REPORT COA2018-034

FILE NO: D20-2018-024

## 88 Chadwin Drive, former Town of Lindsay

Proposed  
Sun Room  
(16'x12')

**Front Elevation (West Side)**

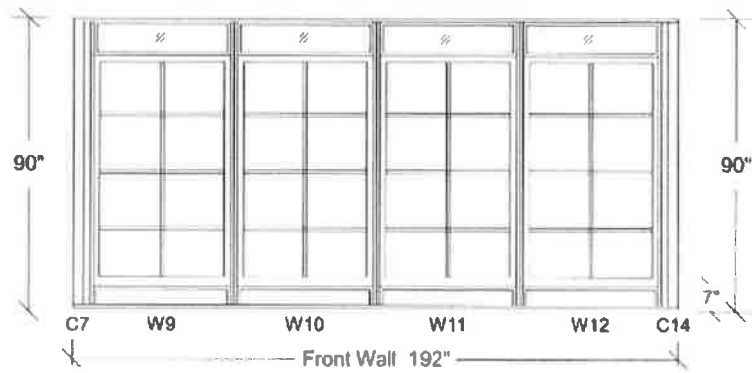
D20-2018-024 Spatial separation requirements of OBC will affect amount of glazing in west wall @ 3.84m setback.
